KNOXVILLE HISTORIC ZONING COMMISSION STAFF REPORT - CERTIFICATE OF APPROPRIATENESS APPLICATION

PROPERTY ADDRESS: 906 Luttrell St 37917

FILE NO.: 11-I-13-HZ

DISTRICT: Fourth and Gill H-1

Architect, Double Hung, 35.5 X 45.5, 4-3/16"

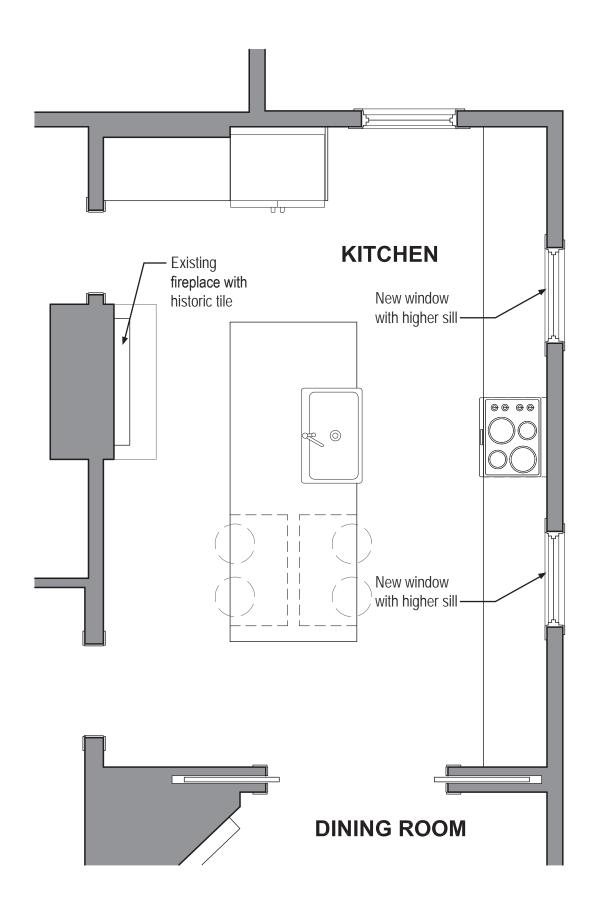
Staff believes it would be possible to preserve the original windows on the south side of the house by adjusting the design of the interior counter and cabinetry in order to retain the full window-opening size.

7) The two double-hung windows proposed to be removed on the south side of the house (toward the rear) are original.

8) The window opening size is a character-defining feature of the house.

Approval of an alternative design for retaining and blocking out the bottom half of two existing south-facing windows from the interior. Approval of rear of house door replacement with double or single (along with sidelight) wood-framed full-light door and opening enlargement. Approval of garage door replacement with specifications for side-hinged-look doors with a wooden appearance to be approved by staff. (Denial of the garage door specifications submitted with this application).

Architect Series® Hinged Patio Door

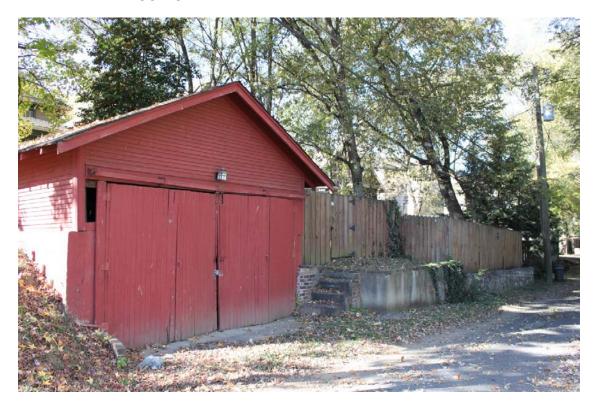
9) The existing rear door on the back of the house is not early, original, or a character-defining feature.

10) Wood-framed full-light glass doors and/or sidelights are appropriate for the rear house door replacement, due to their simple, non-conjectural design.

11) No significant historic material will be lost with the rear door opening enlargement on the back of the house.

906 Luttrell – Existing garage doors

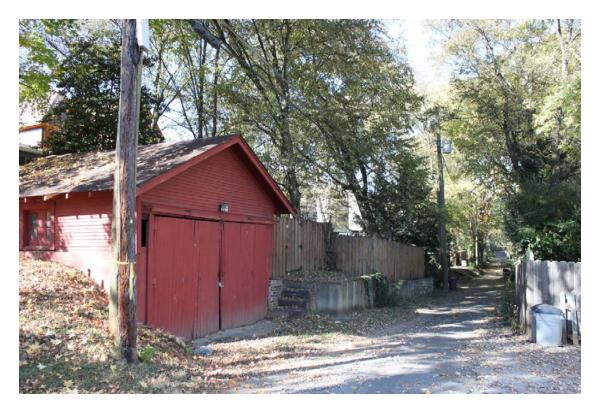
1) The 1920s-1940s frame Craftsman garage with exposed rafters is a character-defining outbuilding on the property.

2) The boarded carriage-house doors are early or original and are a character-defining feature of the building.

3) Typcial character-defining features of carriage-house doors include side hinges, pull handles, and a wood-framed or boarded construction.

4) The garage and its doors are visible from the public alley and somewhat visible from Gill Avenue as indicated in the photos that accompany this report.

5) The wooden board material at the base of the garage doors has become somewhat deteriorated.

6) The doors are not motorized and are therefore not practical for use as a drive-in garage for regular use of a car.
